**Municipality of Anchorage
Geotechnical Advisory Commission**

A G E N D A

Tuesday, April 27, 2021

Subject: Platting Case S12607 - Palaterra Subdivision

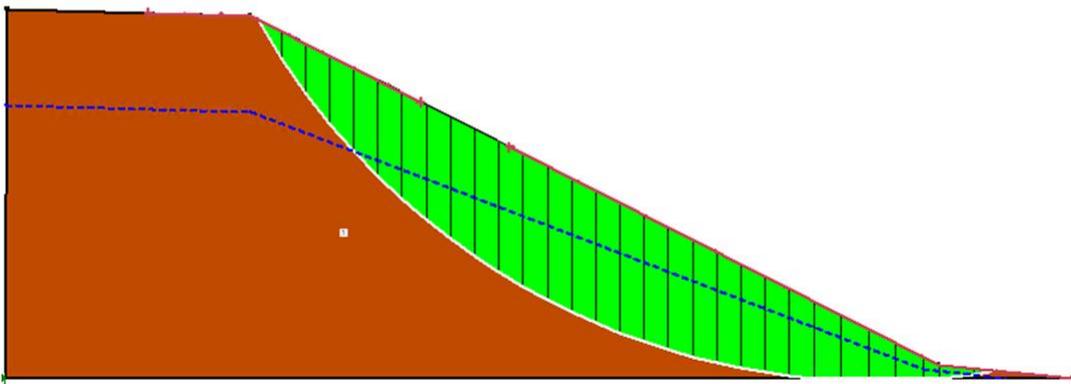
Attached is the proposed plat from S4 group, and the letter drafted from the Rabbit Creek Community Council that was sent to the platting board. Also below is a picture of the slope stability model I built for the slope.

Name	Unit Weight (pcf)	Cohesion' (psf)	Phi' (°)
Silty Sand with Gravel	120	0	30

0.95

**A Preliminary Plat of:
Lots 1-12,
Palaterra Subdivision
Addition 2, with Variance**

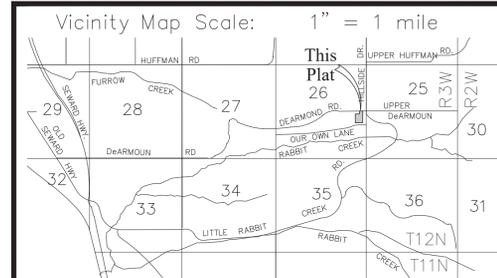
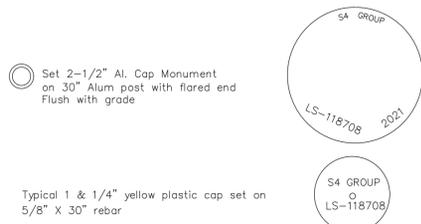
- C. Steep slope conditions of approval. Three lots (numbered 5, 6, and 7) are primarily located on very steep slopes. These slopes are particularly susceptible to potential erosion, slope instability, and/or drainage impacts on down-gradient properties. Our Council area has witnessed slope failures on the same slope less than ¼ mile away (see figure 1) from the proposed development, and spectacular “blowouts” of groundwater during subdivision development, including at Prominence Pointe (figure 2) and in Potter Creek. Title 21.07.020- (Natural Resource Protection, Section C on steep slope development) requires non-disturbance zones for these slopes: yet this can be hard to enforce on private property as shown in Figure 1. Violations can cause irreversible damage that are very difficult to fix. RCCC suggests two possible solutions to ensure stability of the slopes in the proposed subdivision:

- a. Re-draw the lot boundaries for lots 5, 6, and 7 to end at the crest of the slope and create a green belt to encompass the slope. This could be a common open space zone.

- b. Designate the steeply sloped area within lots 4, 5, 6, and 7 as natural undisturbed zones and depict these areas on the plat and through plat notes. Require field marking of this zone prior to, and through, construction.
